Takes of Marine Mammals Incidental to Specified Activities; Taking Marine Mammals Incidental to an Exploration Drilling Program in the Chukchi Sea, Alaska; Notice

ACTION: Notice; issuance of an incidental harassment authorization.

SUMMARY: In accordance with the Marine Mammal Protection Act (MMPA) regulations, notification is hereby given that NMFS has issued an Incidental Harassment Authorization (IHA) to Shell Gulf of Mexico Inc. (Shell) to take marine mammals, by harassment, incidental to offshore exploration drilling on Outer Continental Shelf (OCS) leases in the Chukchi Sea, Alaska.

Figure 1. Source levels in 1/3-octave bands for the drillship Discoverer and ice management surrogate vessel (the ice handler Maersk Rover).

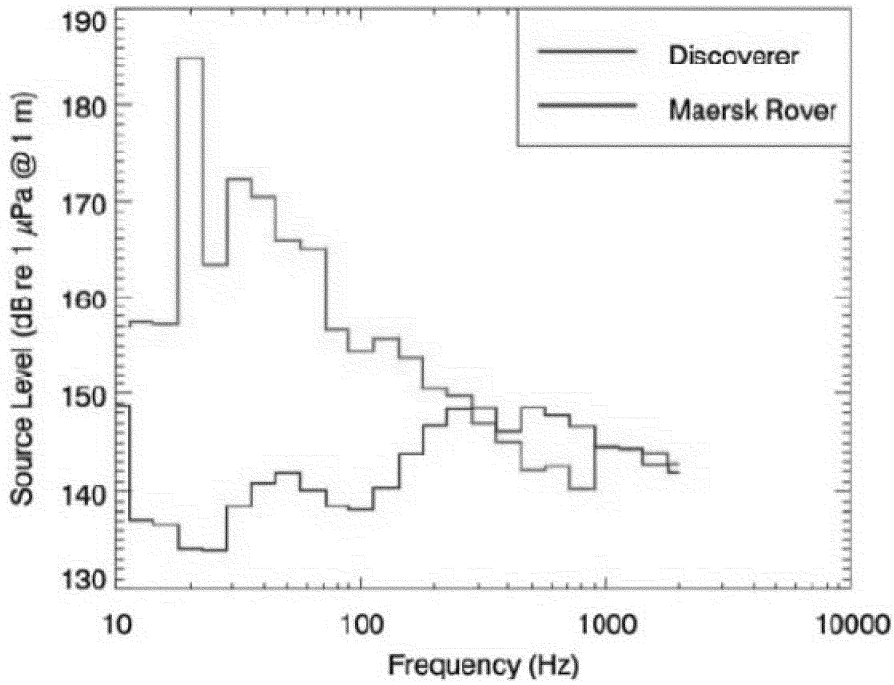
Comment 26: The MMC states that it is not clear which specific source level was used to model the size of the corrected 120-dB re 1 μPa harassment zone for the *Discoverer,* as the reported source levels for the *Discoverer* ranged from 177–185 re 1 μPa at 1 m. It also is not clear how the source level measurements taken in the South China Sea were incorporated in the model to estimate the 120-dB re 1 μPa harassment zone in the Chukchi Sea.

Comment 27: Dr. Bain notes that sound propagation efficiency depends on conditions and that the modeling used by Shell does not capture the most efficient mode of propagation. He also states that there is great uncertainty with source levels based on single measurement locations, as was done for the *Discoverer.*

Response: The modeling analysis considered 1/3-octave band levels to account for frequency-dependent propagation effects that cannot adequately be characterized with broadband analysis. The 1/3-octave band source levels were obtained from dedicated measurements of the *Frontier Discover* (now *Noble Discoverer*) during drilling activities in the South China Sea. A plot showing these levels is provided in the response to *Comment 27,* and the corresponding broadband levels could be computed by summing those if required. The modeling approach applied by JASCO Applied Science was the MONM parabolic equation acoustic propagation model in each 1/3-octave band from 10 Hz to 2 kHz. The resulting received band levels were summed to compute the broadband received levels at many depths, distances and directions from the planned drillship location. Representative sound level threshold radii were determined by calculating the 95th percentile distance, over all azimuths, at which the maximum threshold over all depths was received. This approach considers that animals may sample multiple depths as they pass by the drilling operation.

Response: The concern raised here about variability of profiles is addressed in the response to *Comment 29*. With regard to the question on which source levels were used for modeling, this study considered 1/3-octave band source levels from the *Discoverer* drillship obtained during dedicated measurements performed in 2009 in the South China Sea (Austin and Warner, 2010). The specific levels are representative of the drilling operation since that activity will occur for the majority of time. The source levels used for the ice management vessel are from surrogate measurements of the *Maersk Rover* transiting at 25% power.

Figure 2. Temperature, salinity, and sound speed profiles at the Burger prospect obtained from the GDEM database for October.

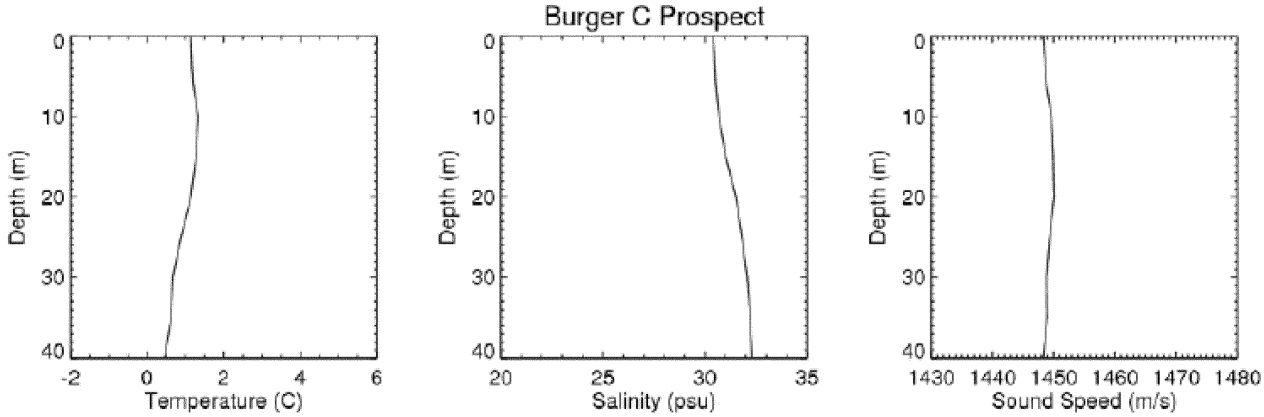
Comment 29: Dr. Bain states that the correction factor of 1.5 applied to the distance to the 120 dB contour is inadequate to conservatively account for the variability.

Response: The concern raised here is that the sound speed profile used for acoustic modeling of drill rig noise may not account for changes to the salinity and temperature profile that could influence and create variability in sound propagation, and the resulting variability might lead to conditions in which model estimates would not be conservative. The location-specific sound speed profiles considered for this modeling study were obtained from the GDEM database for conditions in July and October. A modeling study (Johnston *et al.,* 2009) investigated the difference in sound propagation for both months and showed longer-range sound propagation using the October profile. To be precautionary and to avoid underestimating the propagation, the modeling at the Burger prospect that was used for marine mammal effects assessment was conducted using the October profile (see Figure 2). Therefore, a correction factor of 1.5 is appropriate in this circumstance.

Figure 3. Band levels for the Kulluk during drilling.

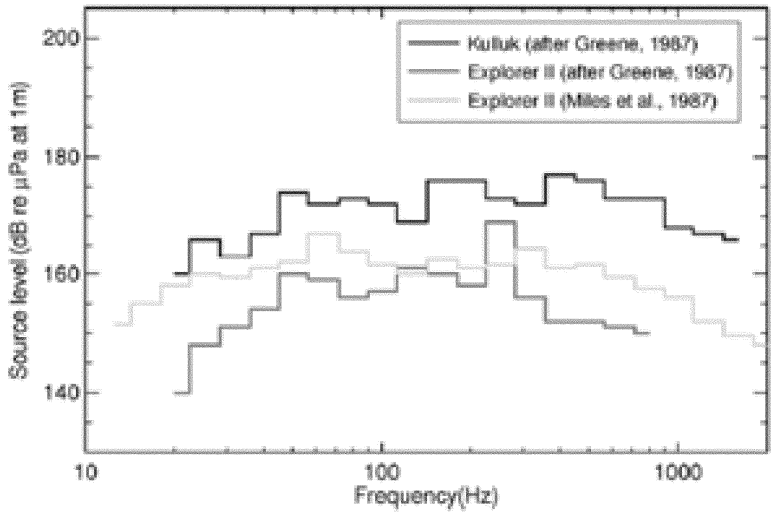
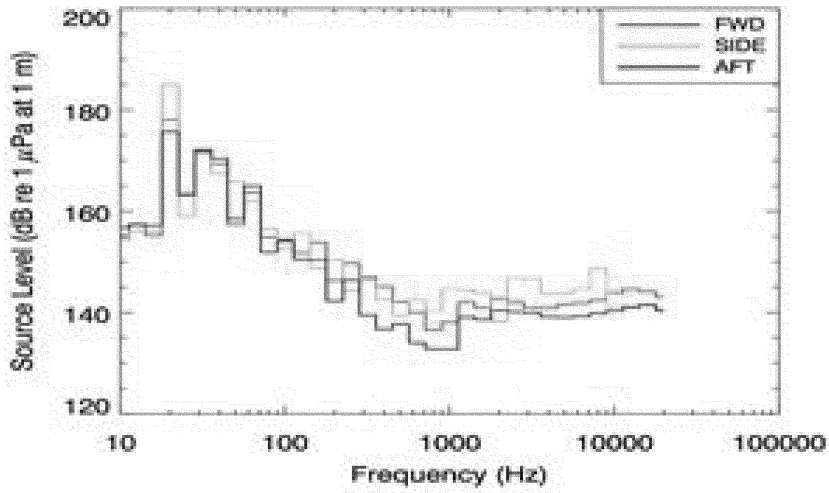
Comment 37: The NSB and AWL note that the modeled 120-dB isopleths for the *Discoverer* are different in the Beaufort and Chukchi Seas (with the isopleth being slightly smaller in the Chukchi Sea). Additionally, they question if the 120-dB isopleth for the *Discoverer* is correct given its nearly identical source level to the *Kulluk* drill rig (proposed for use in the Beaufort Sea), for which sound propagates out to the 120-dB isopleth at a much farther distance. If the modeled propagation is incorrect for the *Discoverer,* then this would bias the take estimates low.

Response: The primary reason for the difference in the distance of the 120-dB isopleths for the *Discoverer* in the Beaufort Sea vs. the Chukchi Sea is due to differences in the geoacoustic parameters for the two seas that were input to the model. Water depth, seabed density, and seabed sound speed are generally the most important parameters that influence sound propagation.

Differences in sound propagation from the two rigs are real and are caused by differences in the design of the two vessels. While the broadband source levels for the *Discoverer* and *Kulluk* may be similar, their spectral properties differ considerably. Acoustic modeling considers the source levels in 1/3-octave frequency bands. Figures 3 and 4 show the band levels for both drillships during drilling. Of key importance are the significantly lower levels of the *Discoverer* in the 50 to 500 Hz bands that propagate well in the relatively shallow waters of these drilling operations. While the *Discoverer* apparently has higher band levels below 50 Hz, this energy is more rapidly attenuated than higher frequency sound energy. This characteristic of sound propagation in shallow waters leads to predominantly mid-frequency sounds (50–500 Hz) dominating the acoustic field at distance from the drillships. A further consideration is that the *Kulluk* source levels are known to include contributions from support vessels, and much of the mid-high frequency band

energy in its source levels may not originate entirely from the drillship itself, as acknowledged by Greene (1987). The *Discoverer* source level measurements by Austin and Warner (2010) were made at closer distances and do not include significant contributions from other vessels. Additionally, the IHA requires Shell to conduct sound source verification and characterization tests on all equipment used.
